UNITED STATES PATENT AND TRADEMARK OFFICE

| APPLICATION NO. | FILING DATE | FIRST NAMED INVENTOR | ATTORNEY DOCKET NO. | CONFIRMATION NO. |
|-----------------|-------------|----------------------|---------------------|------------------|
| 10/037,325 | 01/03/2002 | Harry W. Eberle III | (HWE-107A) | 5841 |

| Office Action Summary | Application No. | Applicant(s) | |

DETAILED ACTION

6,363,677 (Chen et al.)

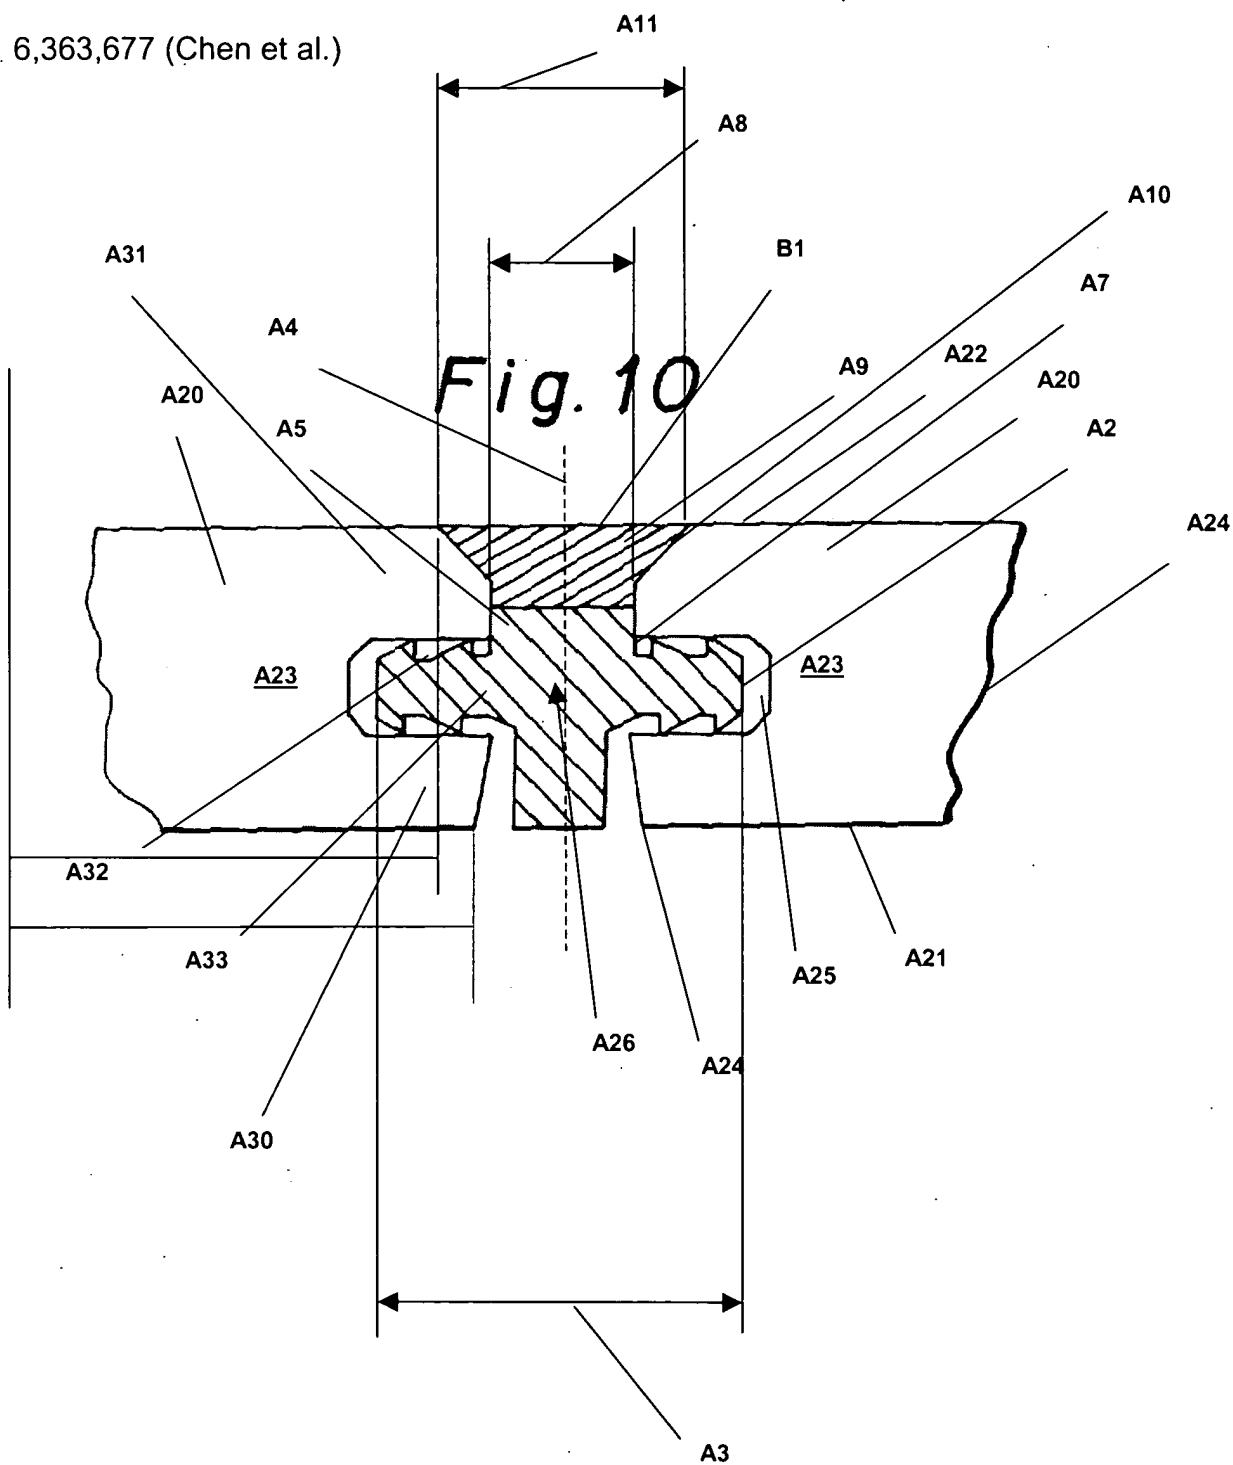
Claims 33 and 35-38 are rejected under 35 U.S.C. 102(e) as being anticipated by Chen et al., 6,363,677 (see marked-up attachment).

Regarding claim 33, Chen discloses in Figure 5, a decking system comprising boards **A20** and an anchoring device **A26**. Each of the boards **A20** has a top **A21**, a bottom **A22**, two sides **A23** and two ends **A24**. At least one groove **A25** is located along one of the sides **A23**. The anchoring device **A26** consists essentially of a substantially flat horizontal top element **A1**, at least one substantially vertical support member **A5**, and a substantially flat horizontal bottom element **A9**. The top element **A1** has a top view configuration including two sides **A2** and a predetermined first width **A3** as measured side to side. The first width **A3** is measured at a maximum width between the sides **A2**. The top element **A1** has an imaginary center line **A4**. The support member **A5** is attached to an underside **A6** of the top element **A1** along the center line **A4** and the support member **A5** extends downwardly therefrom. The support member **A5** has two sides **A7** and a predetermined second width **A8** as measured side to side at a maximum width. The bottom element **A9** has a flat bottom view configuration, which includes sides **A10**, and having a generally trapezoidal shape, and a predetermined third width **A11** as measured side to side at a maximum width at a trapezoidal base **B1**. The first width **A3** is greater than the second width **A8** and the third width **A11**. The third width **A11** is greater than the second width **A8**. The device is made of molded plastic material capable of having a metal fastener driven through (col. 7, lines 56-60).

Regarding claim 35, the two sides **A2** of the top element **A1** are symmetric to one another.

Regarding claim 36, the groove **A25** establishes an upper half **A30** of each of the boards **A20** above the groove **A25** and a lower half **A31** of each of the boards **A20** below the groove **A25**. The upper half **A30** has a greater width than the lower half **A31**. Compare widths **A32** and **A33**.

Regarding claim 37, the boards **A20** are made of material selected from the group consisting of synthetic polymers, at least partially foamed synthetic polymers, wood, wood composite, and combinations thereof (col. 4, lines 22-50).

Regarding claim 38, the two sides **A2** of the top element **A1** are parallel to one another.

556,998 (Major)

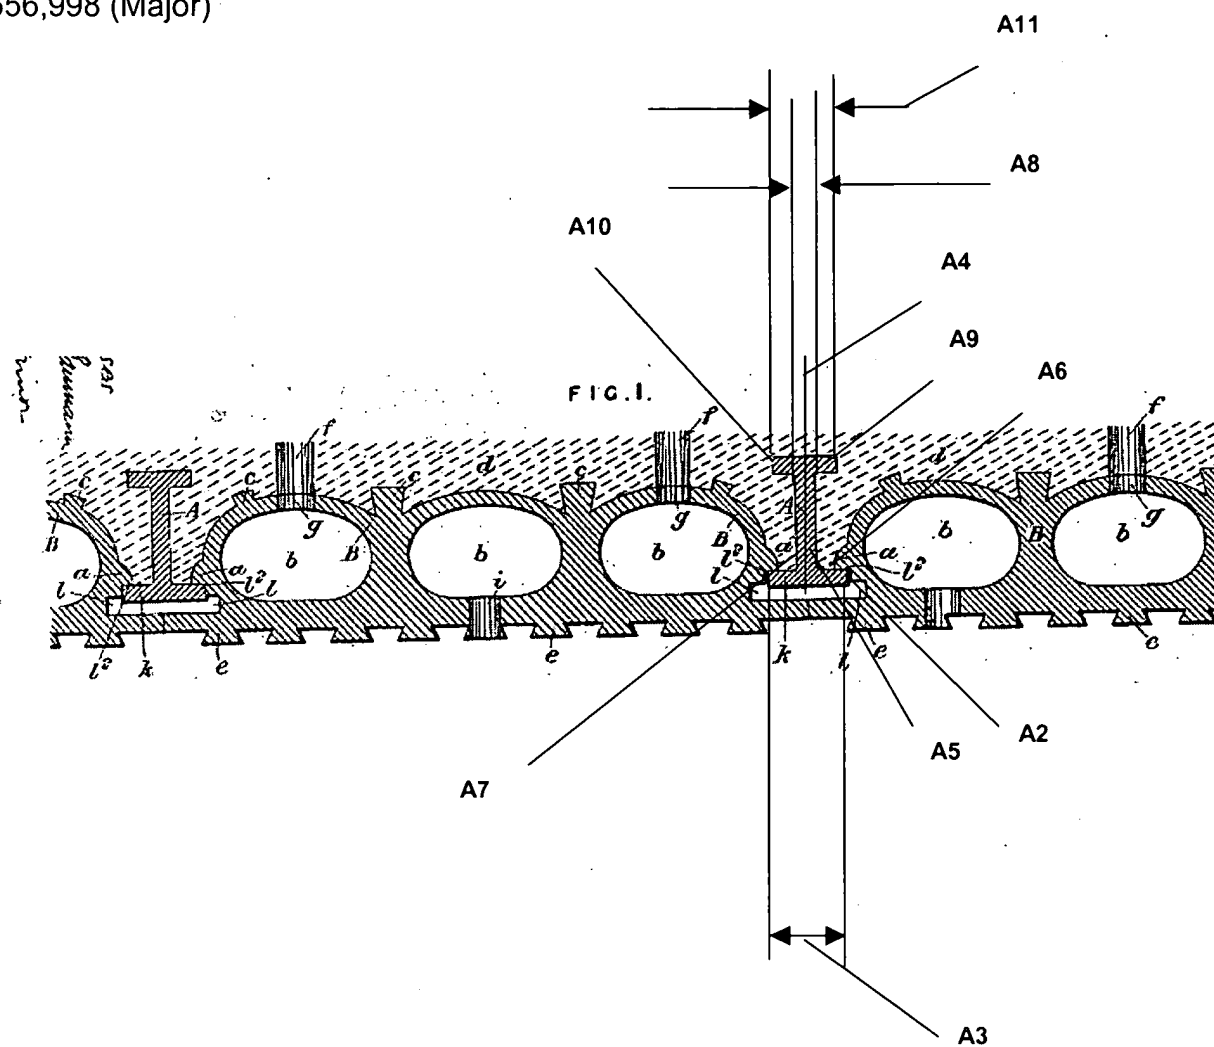
Claim 33 is rejected under 35 U.S.C. 103(a) as being unpatentable over Major, 556,998 (see marked-up attachment), in view of Fisher et al., 5,704,181.

Regarding claim 33, Major, discloses, in Figure 1, a decking system comprising boards **B** and an anchoring device **A**. Each of the boards **B** has a top **e**, a bottom **c**, two sides **I2** and two ends (Fig. 2A). At least one groove **I** is located along one of the sides **I2**. The anchoring device **A** consists essentially of a substantially flat horizontal top element **k**, at least one substantially vertical support member **A5**, and a substantially flat horizontal bottom element **A9**. The top element **k** has a top view configuration including two sides **A2** and a predetermined first width **A3** as measured side to side. The first width **A3** is measured at a maximum width between the sides **A2**. The top element **k** has an imaginary center line **A4**. The support member **A5** is attached to an underside **A6** of the top element **k** along the center line **A4** and the support member **A5** extends downwardly therefrom. The support member **A5** has two sides **A7** and a predetermined second width **A8** as measured side to side at a maximum width. The bottom element **A9** has a flat bottom view configuration, which includes sides **A10**, and a predetermined third width **A11** as measured side to side at a maximum width at a

base. The first width **A3** is greater than the second width **A8** and the third width **A11**.

The third width **A11** is greater than the second width **A8**.

However, Major, fails to disclose, the bottom element **A9** having a generally trapezoidal shape, and making the anchoring device **A** of molded plastic material.
